Form 3160-5  
(June 2019)UNITED STATES  
DEPARTMENT OF THE INTERIOR  
BUREAU OF LAND MANAGEMENTFORM APPROVED  
OMB No. 1004-0137  
Expires: October 31, 2021**SUNDRY NOTICES AND REPORTS ON WELLS**  
**Do not use this form for proposals to drill or to re-enter an abandoned well. Use Form 3160-3 (APD) for such proposals.**

8. Well Name and No. RUTHLESS 11 FED COM/511H

EOG respectfully requests an amendment to our approved APD for this well to reflect the following changes:

#### Revised Permit Information 03/04/2022:

## WELL LOCATION AND ACREAGE DEDICATION PLAT

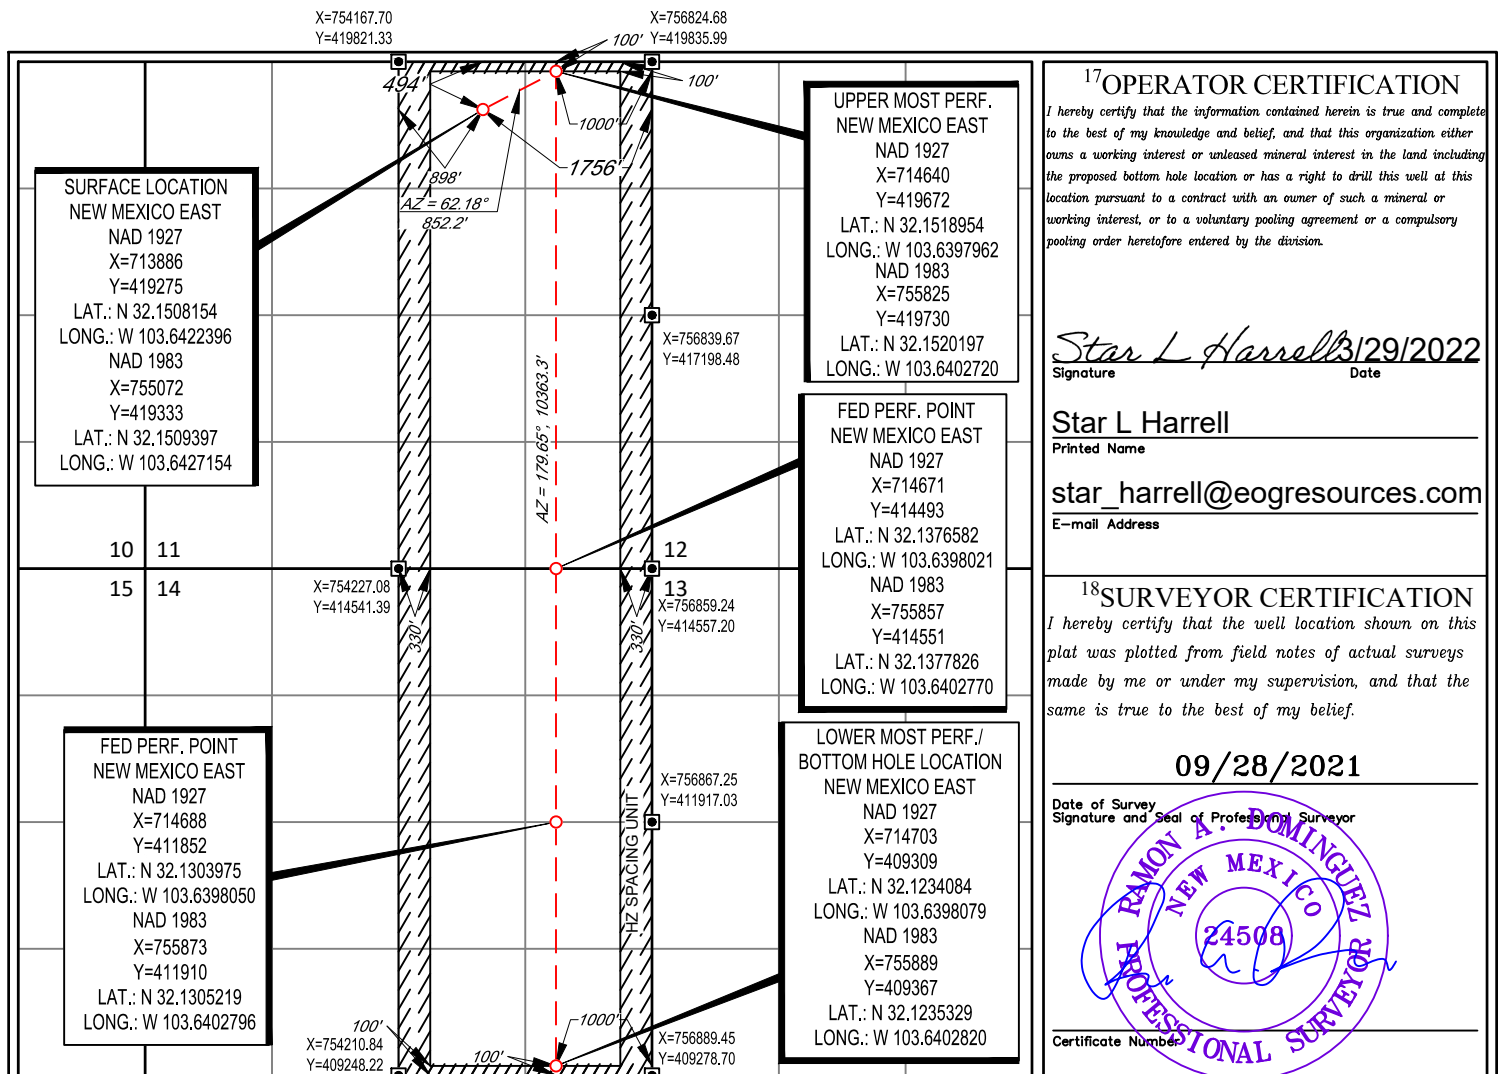
Change name from 511H to Ruthless 11 Fed Com 750H.

Change SHL from T-25-S, R-32-E, Sec 11, 600' FNL, 2708' FEL, Lea Co., NM, to T-25-S, R-32-E, Sec 11, 494' FNL, 1756' FEL, Lea Co., N.M.

Change BHL from T-25-S, R-32-E, Sec 14, 100' FSL, 2180' FEL, Lea Co., NM, to T-25-S, R-32-E, Sec 14, 100' FSL, 1000' FEL, Lea Co., N.M.

UL or lot no.	Section	Township	Range	Lot Idn	Feet from the	North/South line	Feet from the	East/West line	County
<b>B</b>	<b>11</b>	<b>25-S</b>	<b>32-E</b>	<b>-</b>	<b>494'</b>	<b>NORTH</b>	<b>1756'</b>	<b>EAST</b>	<b>LEA</b>

UL or lot no.	Section	Township	Range	Lot Idn	Feet from the	North/South line	Feet from the	East/West line	County
<b>P</b>	<b>14</b>	<b>25-S</b>	<b>32-E</b>	<b>-</b>	<b>100'</b>	<b>SOUTH</b>	<b>1000'</b>	<b>EAST</b>	<b>LEA</b>

Figure 1: Cameron TA Plug and Offline Adapter Schematic

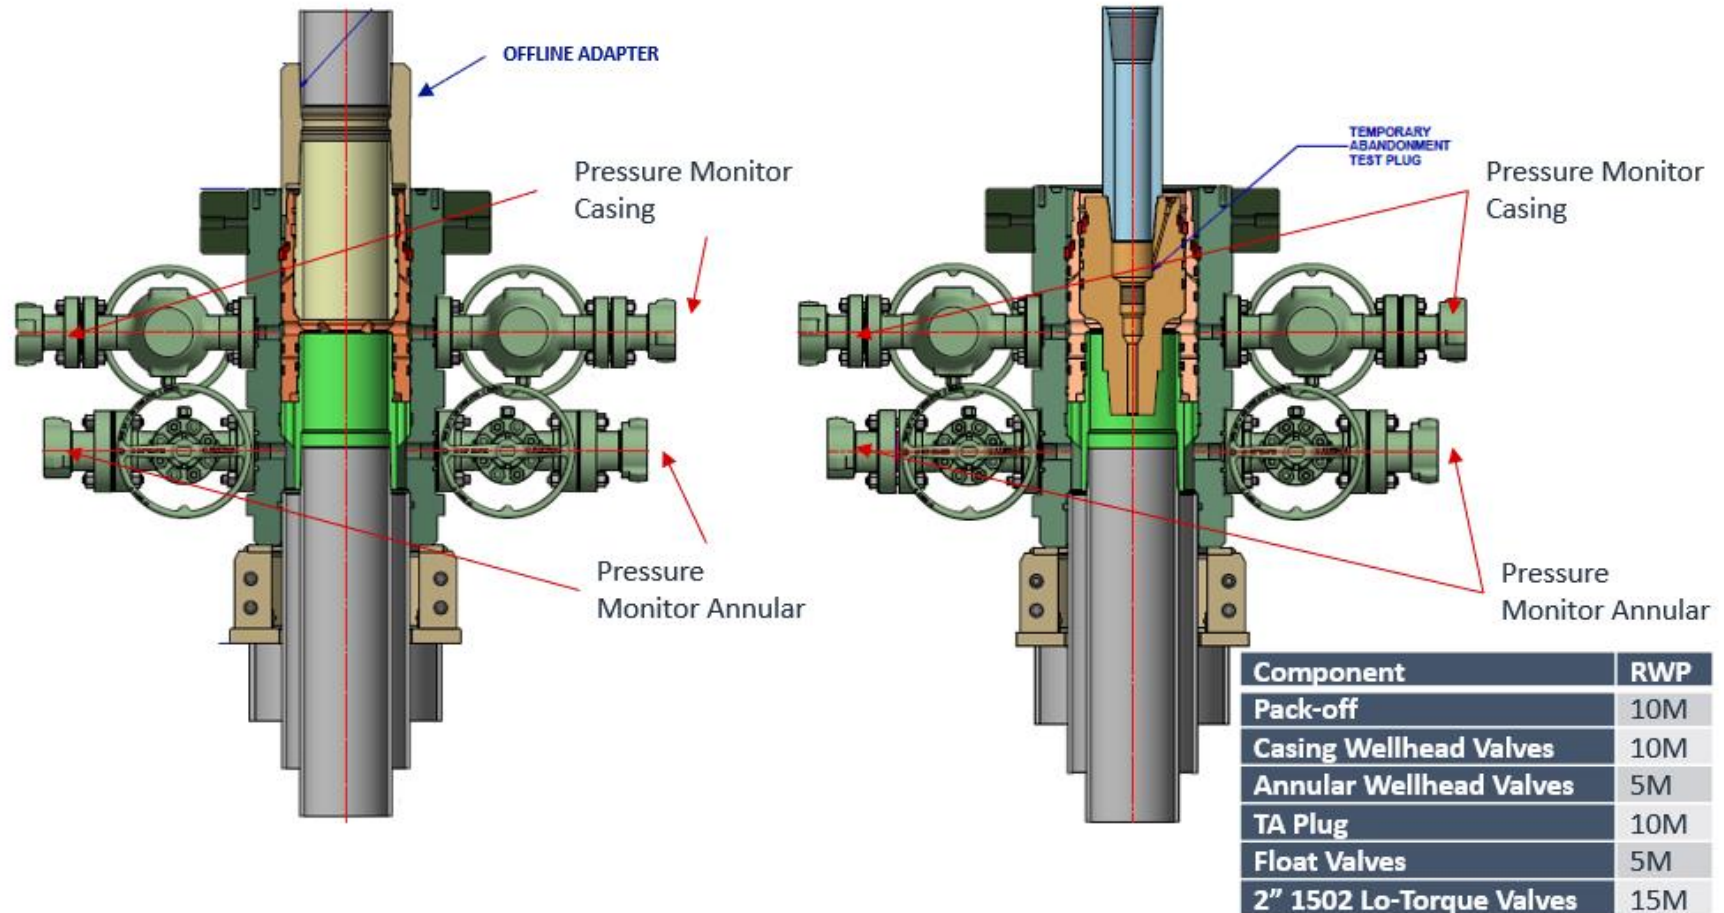
- c. Return line schematics can be seen in Figure 3.
10. Remove TA Plug from the casing.
11. Install offline cement tool.
  - a. Current offline cement tool schematics can be seen in Figure 1 (Cameron) and Figure 2 (Cactus).

Figure 4: Rig Placement Diagram

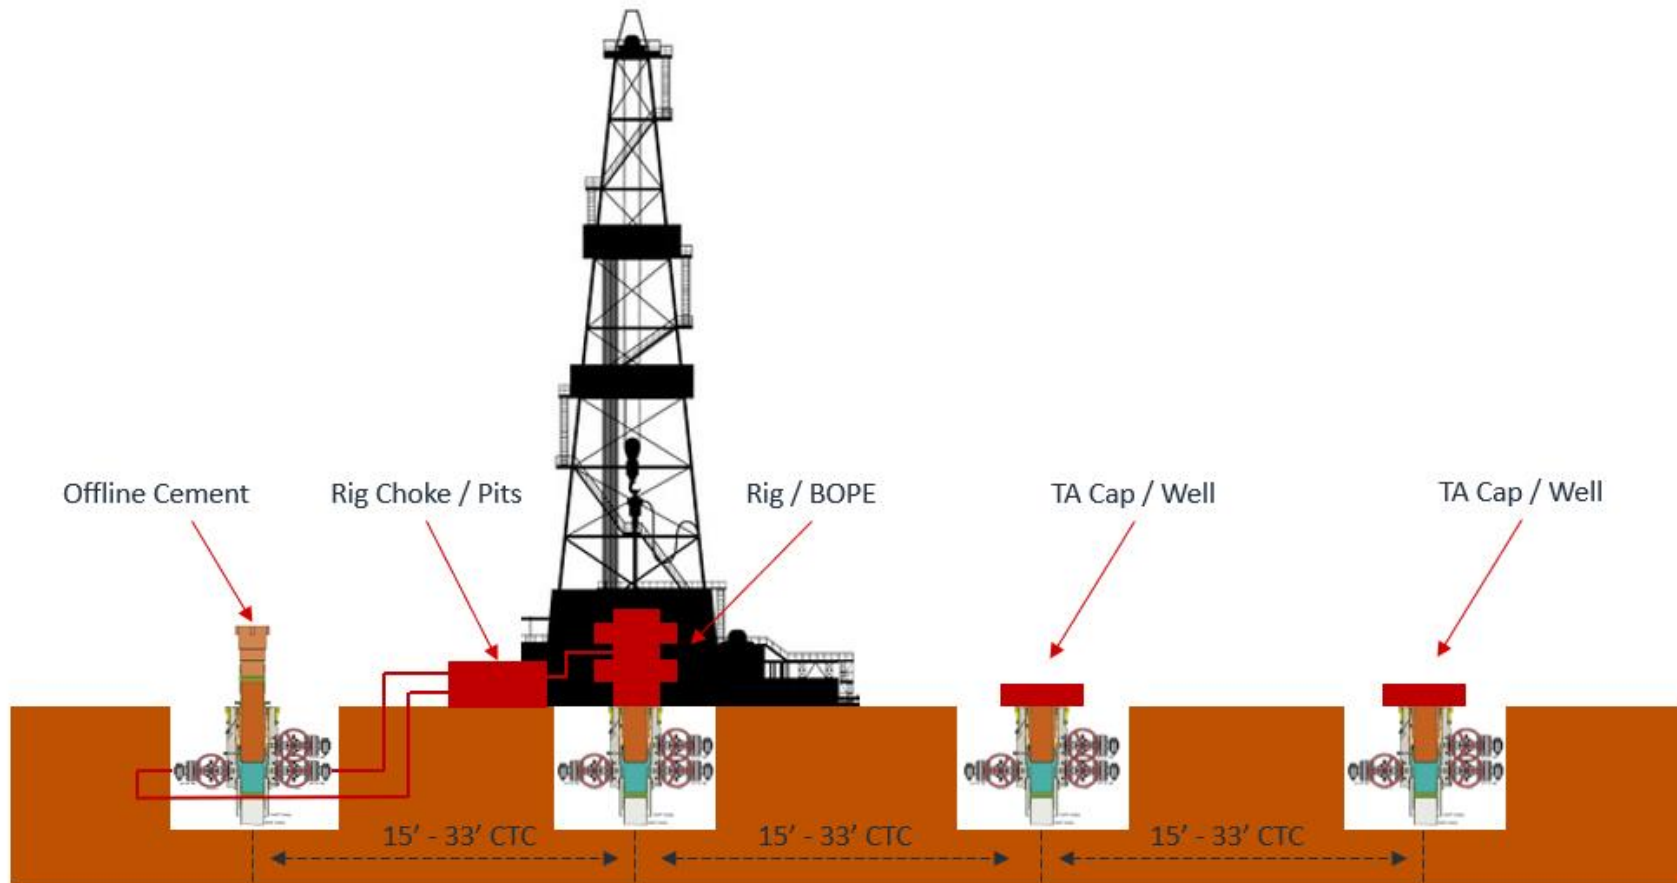
- e. Diagram for rig positioning relative to offline cementing can be seen in Figure 4.
9. Rig up return lines to take returns from wellhead to pits and rig choke.
